VARIANCE CORRECTIONS 1

Hartman Residence - Room Addition

22 Ethel Lane
Mill Valley, Ca. 94941
e-mail margaret1110@gmail.com
Assessor's Parcel No. 048-061-54

PRELIMINARY DRAINAGE PLAN

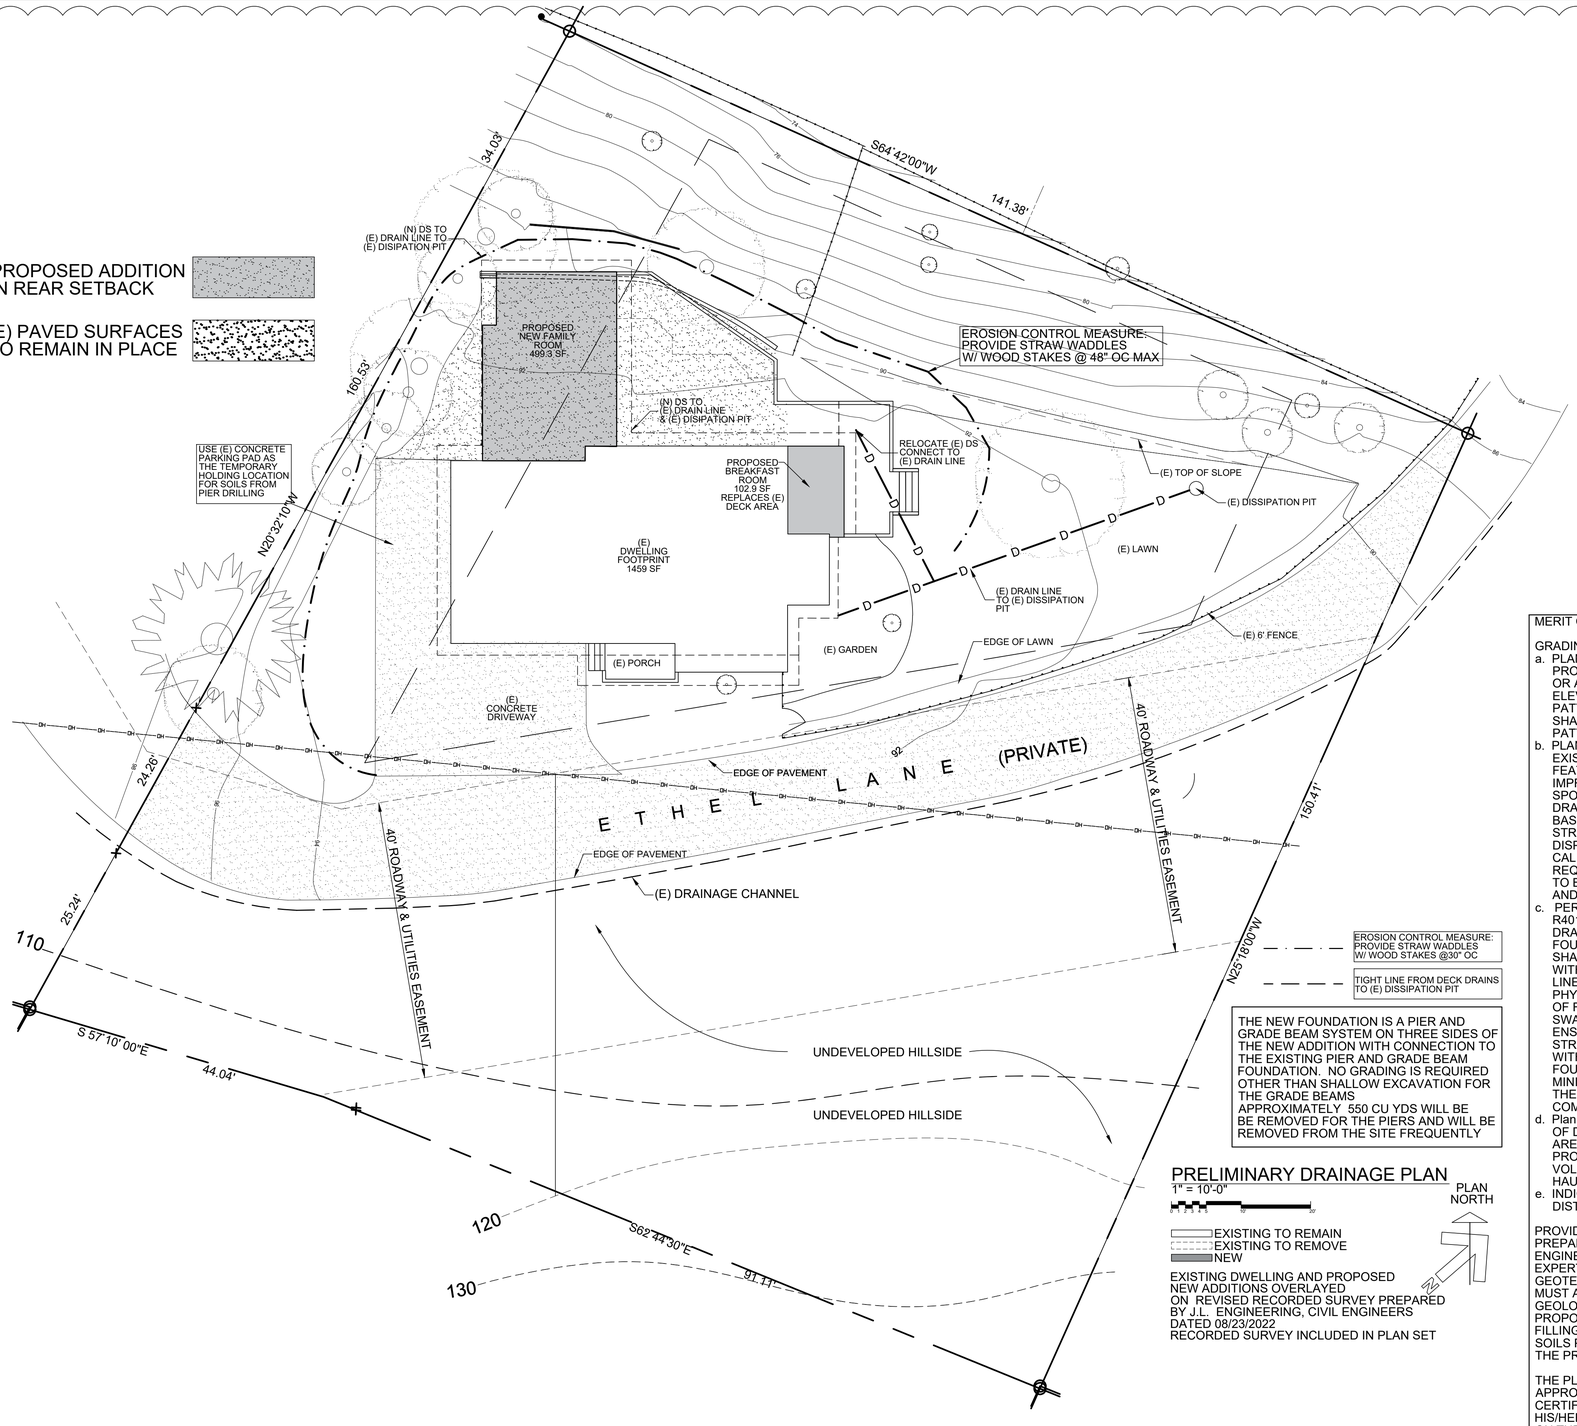
MERIT COMMENTS:

GRADING & DRAINAGE PLANS:

a. PLAN SHALL PROVIDE EXISTING AND PROPOSED TOPOGRAPHIC CONTOURS, OR A SUFFICIENT NUMBER OF SPOT ELEVATIONS, TO DESCRIBE DRAINAGE PATTERNS. The PROPOSED PROJECT SHALL MAINTAIN EXISTING DRAINAGE PATTERNS

b. PLAN SHALL SHOW AND LABEL ALL EXISTING AND PROPOSED DRAINAGE FEATURES AND IMPROVEMENTS. IMPROVEMENTS MAY INCLUDE DOWN SPOUTS, FOOTING AND FOUNDATION DRAINS, AREA DRAINS AND CATCH BASINS, PIPING AND OUT FALL STRUCTURES OR MEANS OF DISPERSION. NOTE THAT 2016 CALIFORNIA PLUMBING CODE 1101.12.1 REQUIRES ROOF AREAS OF BUILDINGS TO BE DRAINED BY ROOF AND DRAINS AND GUTTERS.

c. PER CALIFORNIA RESIDENTIAL CODE R401.3, LOTS SHALL BE GRADED TO DRAIN SURFACE WTER AWAY FROM FOUNDATION WALLS. THE GRADE SHALL FALL A MINIMUM OF 6 INCHES WITH THE FIRST 10 FEET. WHERE LOT LINES, WALLS, SLOPES, OR OTHER PHYSICAL BARRIERS PROHIBIT 6 INCHES OF FALL WITHIN 10 FEET, DRAINS OR SWALES SHALL BE CONSTRUCTED TO ENSURE DRAINAGE AWAY FROM THE STRUCTURE. IMPERVIOUS SURFACES WITHIN 10 FEET OF THE BUILDING FOUNDATION SHALL BE SLOPED A MINIMUM OF 2 PERCENT AWAY FROM THE BUILDING. DEMONSTRATE COMPLIANCE.

d. Plan SHALL SHOW AND LABEL THE LIMIT OF DISTURBANCE. PROVIDE THE TOTAL AREA TO BE DISTURBED AND THE PROPOSED CUT AND FILL EARTHWORK VOLUMES. INDICATE TO WHERE OFF HAUL WILL BE TAKEN.

e. INDICATE MEANS OF RESTORING ALL DISTURBED AREAS.

PROVIDE A GEOTECHNICAL REPORT PREPARED BY A REGISTERED CIVIL ENGINEER WITH SOILS ENGINEERING EXPERTISE OR A REGISTERED GEOTECHNICAL ENGINEER. THE REPORT MUST ATTEST TO THE SUITABILITY AND GEOLOGICAL FEASIBILITY OF THE PROPOSED CONSTRUCTION (CUTTING AND FILLING) AND IDENTIFY ANY DRAINAGE OR SOILS PROBLEMS THAT THE DESIGN OF THE PROJECT MUST ACCOMMODATE.

THE PLANS MUST BE REVIEWED AND APPROVED BY THE SOILS EINGINEER. CERTIFICATION SHALL BE EITHER BY HIS/HER STAMP AND ORIGINAL SIGNATURE ON THE PLANS OR BY A STAMPED AND SIGNED LETTER. CERTIFICATION SHALL REFERENCE PLANS REVIEWED, SPECIFYING SITE, STRUCTURAL AND DRAINAGE PLANS WITH DATE OF DRAWINGS, AND VERIFY THAT PLANS ADDRESS ANY RECOMMENDATIONS PREVIOUSLY OFFERED.

THE NEW FOUNDATION IS A PIER AND GRADE BEAM SYSTEM ON THREE SIDES OF THE NEW ADDITION WITH CONNECTION TO THE EXISTING PIER AND GRADE BEAM FOUNDATION. NO GRADING IS REQUIRED OTHER THAN SHALLOW EXCAVATION FOR THE GRADE BEAMS
APPROXIMATELY 550 CU YDS WILL BE BE REMOVED FOR THE PIERS AND WILL BE REMOVED FROM THE SITE FREQUENTLY
